Appendix O: Impoundment Fluctuation and Minimum Flow Release Plan

**WORONGCO PROJECT
(FERC No. 2631)**

COMPREHENSIVE FISH PASSAGE PLAN

Woronoco Project (FERC No. 2631)
Impoundment Fluctuation and Minimum Flow Monitoring Plan – Article 403

Photo 1: View of Bypass Confluence Area

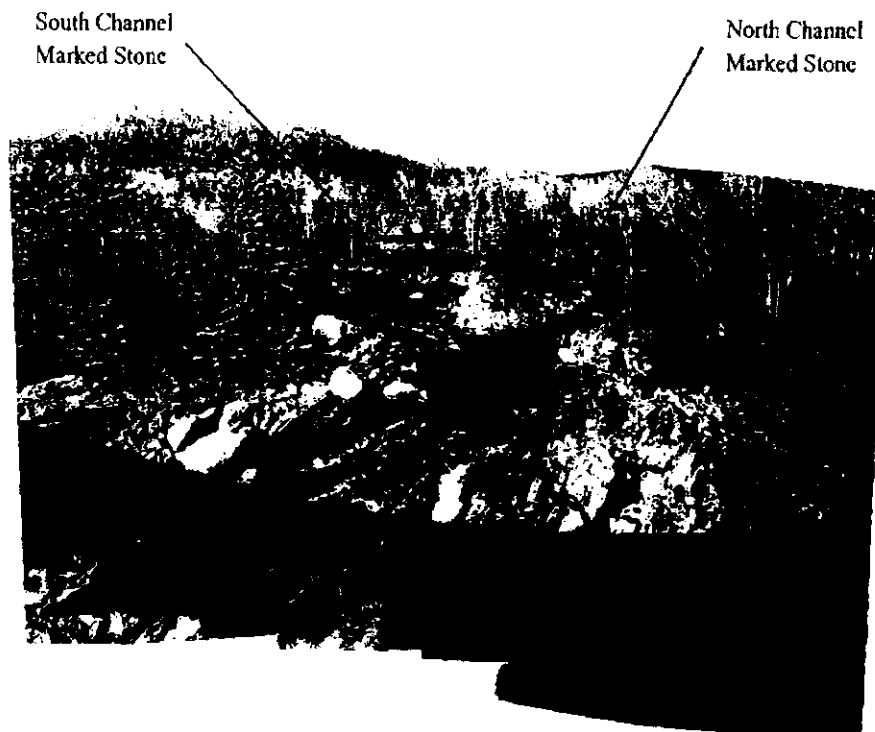
Thank you for your response. The photo (page 6) in the plan is misleading in that it is looking upstream into the two separate channels. The discharge into each channel is separated by an embankment keeping the two channel flows from merging until the area indicated by the photo. Flows into each channel is controlled through separate discharge gates which we do monitor separately.

I'm sorry I won't be able to join you in your conference call, as I'm heading off to a meeting in a few minutes. I did however, run the Monitoring Plan past one of my surface-water specialists for comment, and he had only one question. On page 3 under "Minimum Flow", the document states that of the 57-cfs release, 35-cfs goes into the south channel and 22-cfs in to the north bypass channel. His question was, if 35-cfs is mandated for the south channel and 22-cfs is mandated for the north channel, and all outflows merge into the pooled area upstream of both channels, what controls the set flows into the south and north channel? Do you monitor flows in each channel to ensure the 35 and 22 cfs set flows are being achieved?
